香港觀鳥會
THE
HONG
KONG
BIRD
WATCHING
SOCIETY

29 March 2019

**Comments on the Environmental Impact Assessment for Yuen Long Effluent Polishing
Plant - Investigation, Design and Construction (EIA-259/2019)**

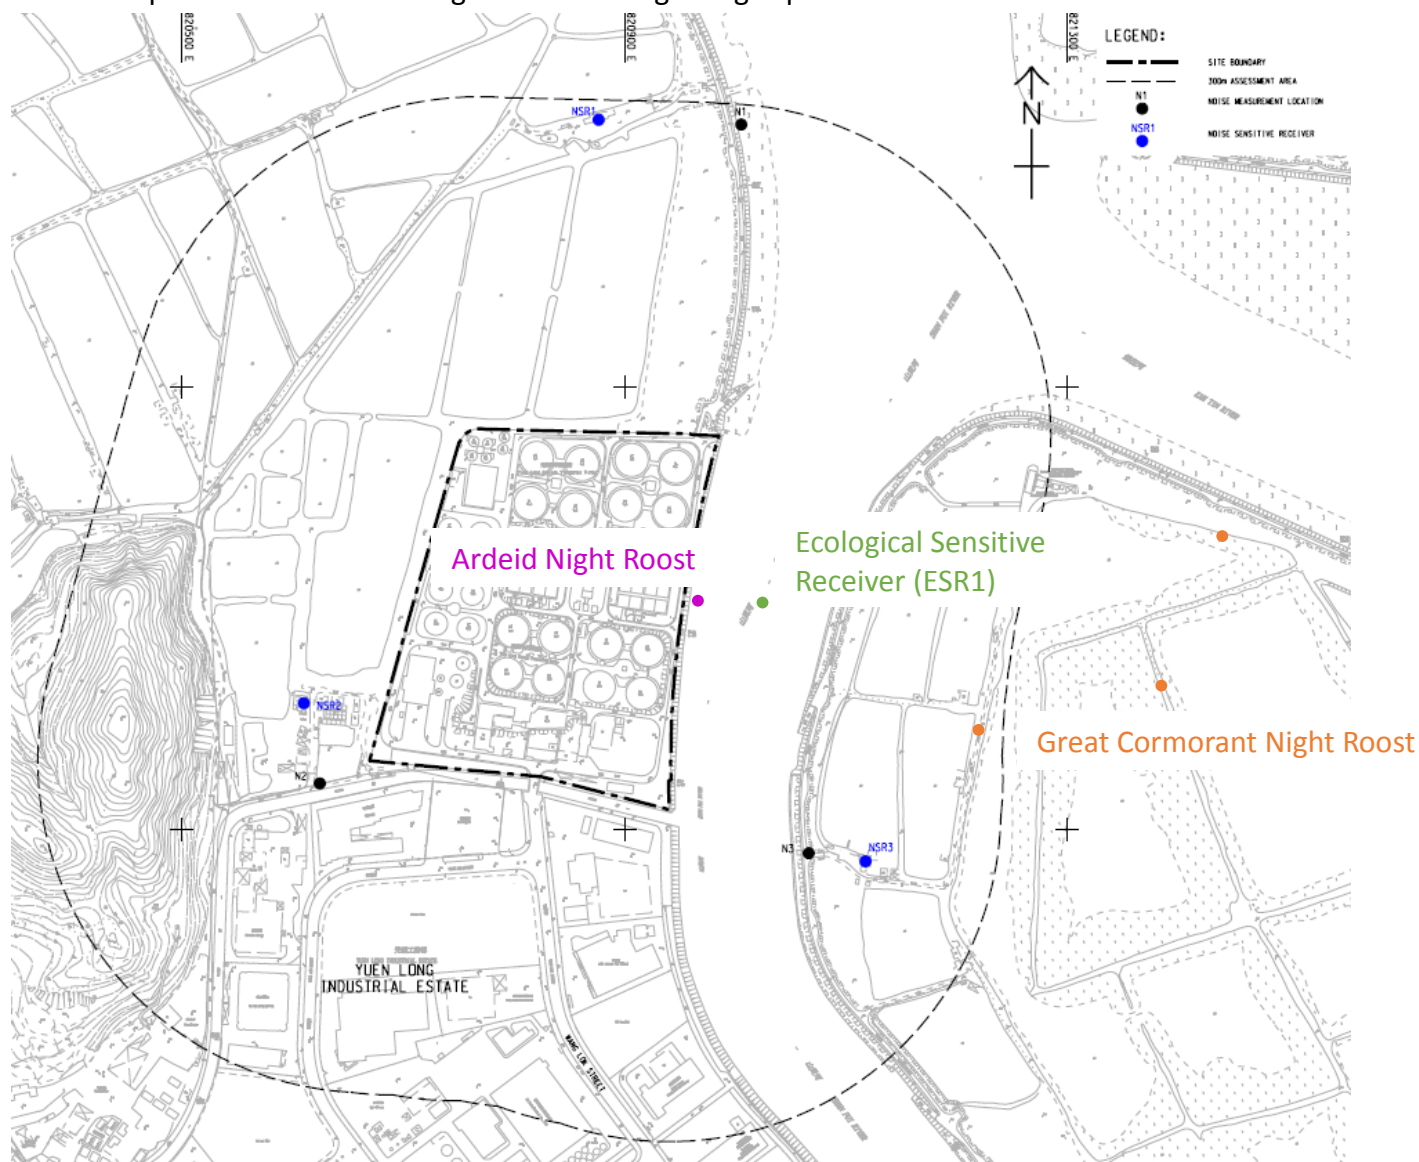
Ecological sensitive receivers (ESRs) such as the ardeid night roost east of the YLEPP, the mudflats along the Shan Pui River and Kam Tin River (Figure 1) and the Great Cormorant night roost in Nam Sang Wai are not included in Section 4 (noise impact assessment) of the EIA report. Some of these ESRs are **in much closer distance** to the project site than all the noise sensitive receivers (NSRs) identified in the EIA, **hence the ESRs are receiving significant noise disturbance from the project site during the construction phase even under the mitigated scenario as stated in section 4 of the EIA**. A middle point in the section of the Shan Pui River adjacent to the YLEPP was taken as ESR1 (Figure 2), and the estimated construction noise received by ESR1 was recalculated under the mitigated scenario and methodology as stated in Section 4 of the EIA report (please refer to Appendix 1). **The noise level at ESR1 was found to be particularly high during the demolition of the inlet works and biological/tertiary treatment facilities from April 2020 to October 2021, with an estimated noise level of 78 dB(A) to 81 dB(A) which is equivalent to a diesel freight train running at high speed at 25m⁸.**

Figure 1. We have recorded waterbirds and wetland dependent birds, including the globally endangered Black-faced Spoonbill, foraging in the upper course of Shan Pui River (MW3), in the Shan Pui River adjacent to YLEPP (MW2), and at the confluence of Shan Pui River and Kam Tin River (MW1). We are concerned the bird usage in these areas would be affected during the construction of the proposed project. Photographs were taken at Shan Pui River in November 2017.

Location of Noise Sensitive Receiver and Construction Site Boundary (Phase 2)

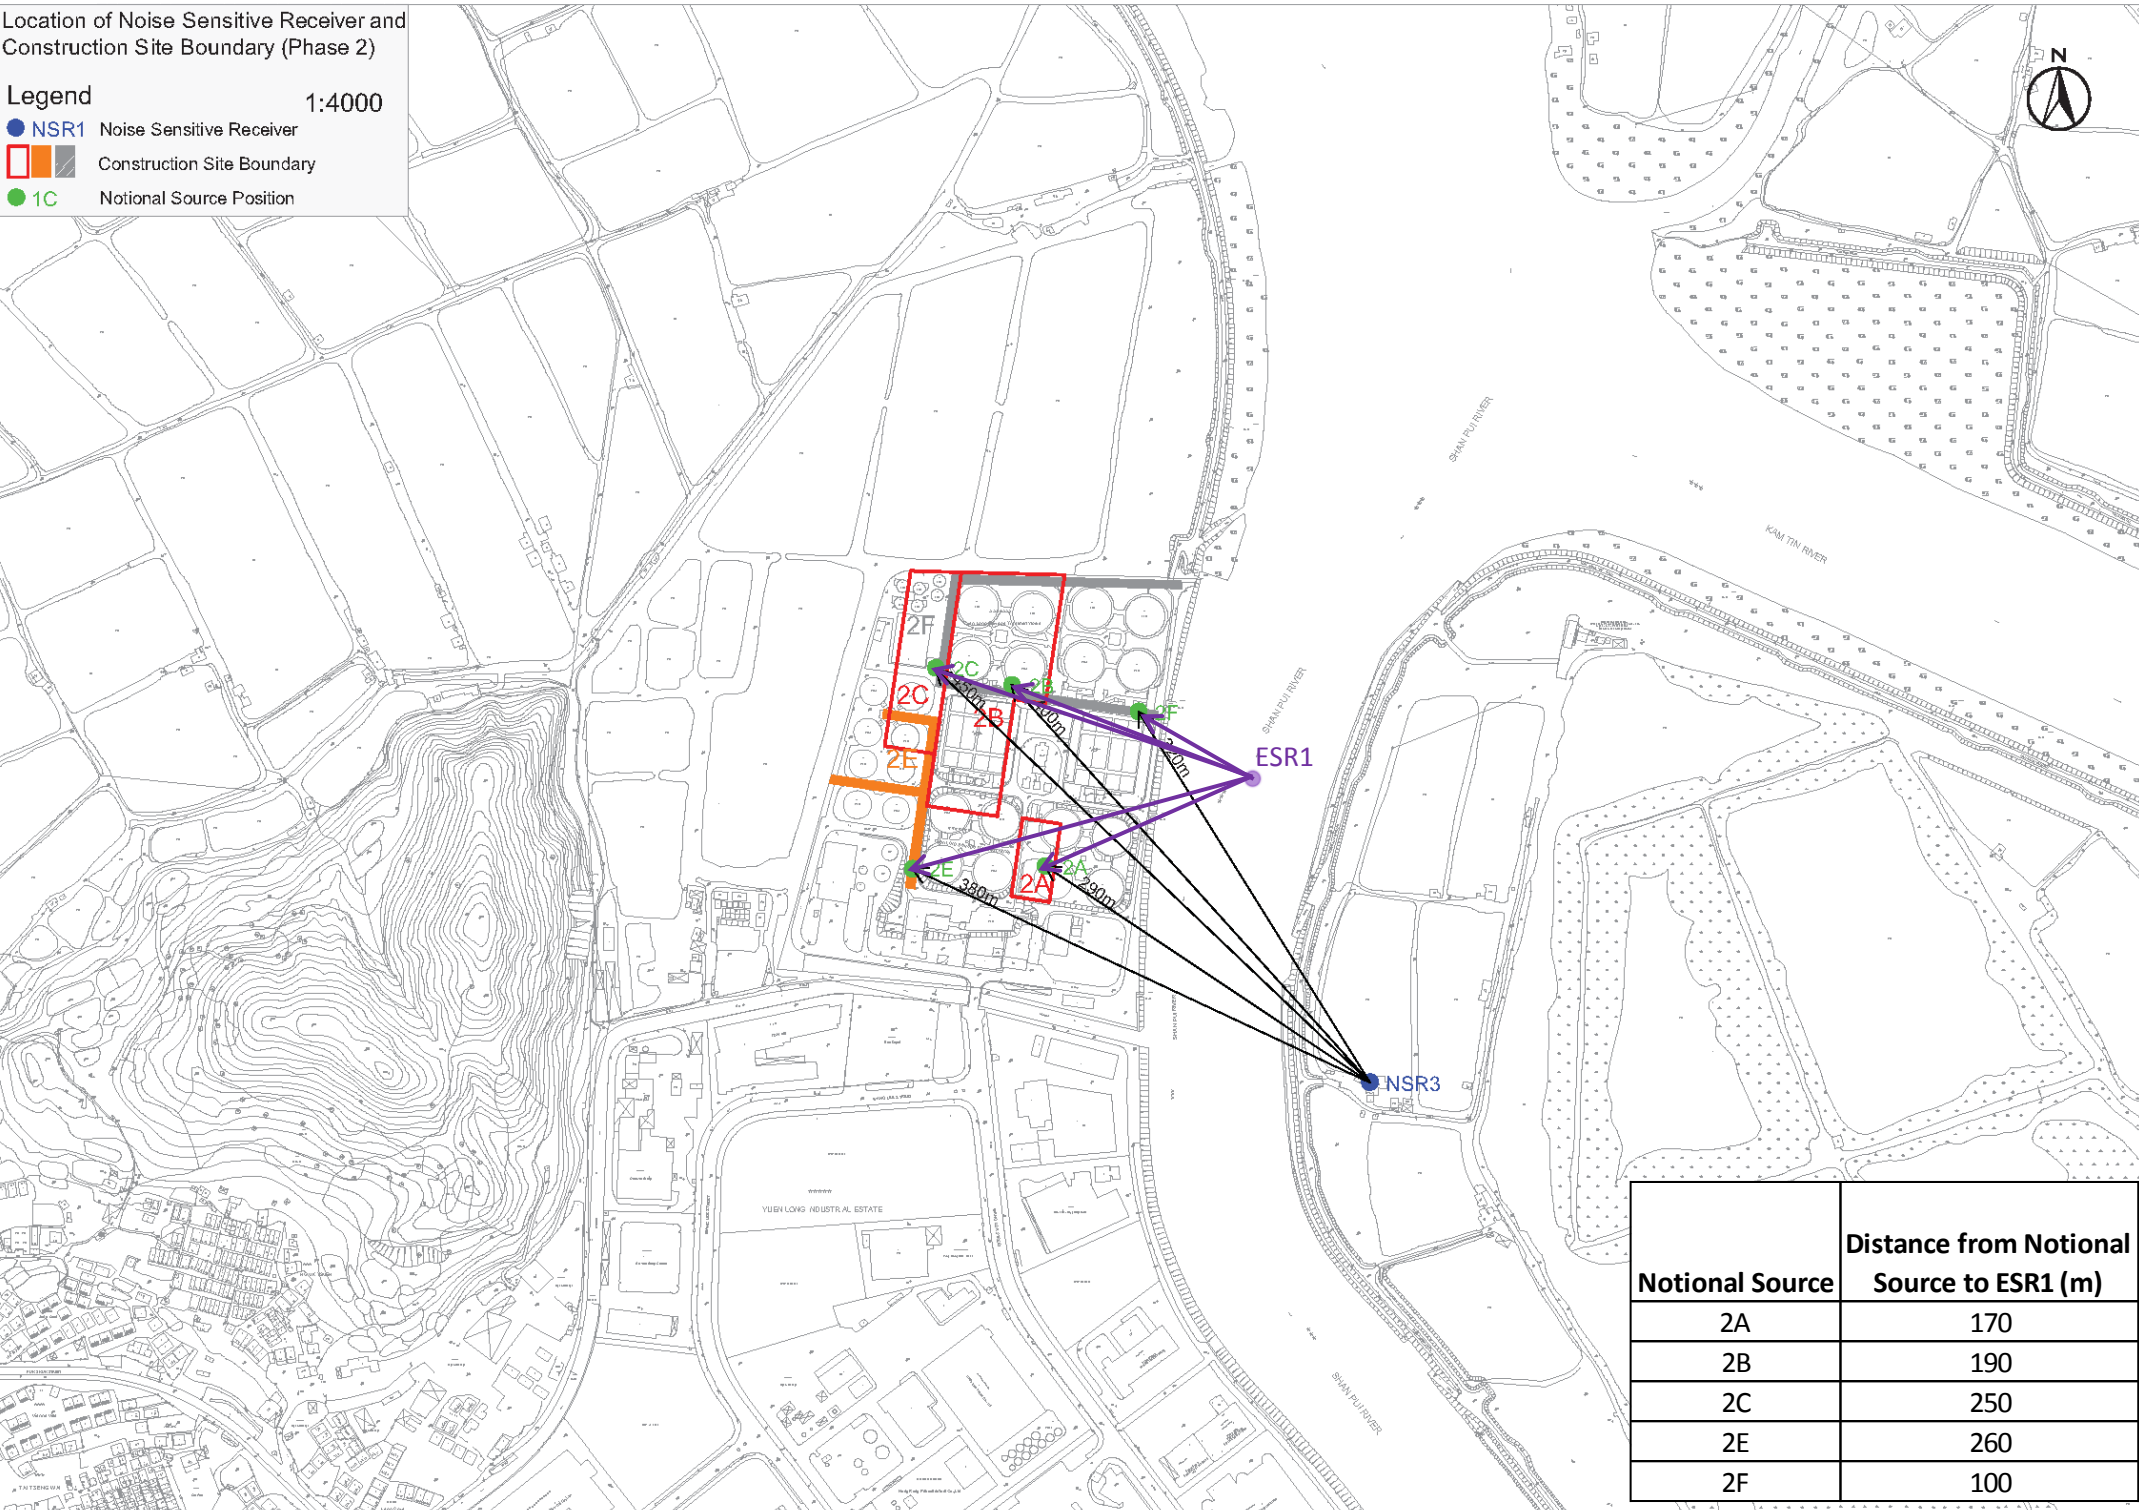
Most of the noise mitigation measures proposed in the ecological impact assessment (section 8 of the EIA) **were adopted** in the construction noise calculation under the mitigated scenario in the noise impact assessment (section 4 of the EIA), **apart from the 4m high noise barriers** with absorptive materials to be erected along the northern, eastern and western sides of the project site. **Under such “mitigated” scenario without the 4m high noise barrier, the estimated noise level at Shan Pui River (ESR1) would still reach 78 dB(A) to 81 dB(A)** (please refer to the above section and Appendix 1).

Figure 2. A middle point in the section of the Shan Pui River adjacent to the YLEPP was taken as ESR1 (Ecological Sensitive Receiver), and the construction noise received by ESR1 was recalculated under the mitigated scenario and methodology as stated in Section 4 of the EIA report (please refer to Appendix 1). The noise level at ESR1 was found to be particularly high during the demolition of the inlet works and biological/tertiary treatment facilities from April 2020 to October 2021, with an estimated noise level of 78 dB(A) to 81 dB(A) which is equivalent to a diesel freight train running at high speed at 25m.
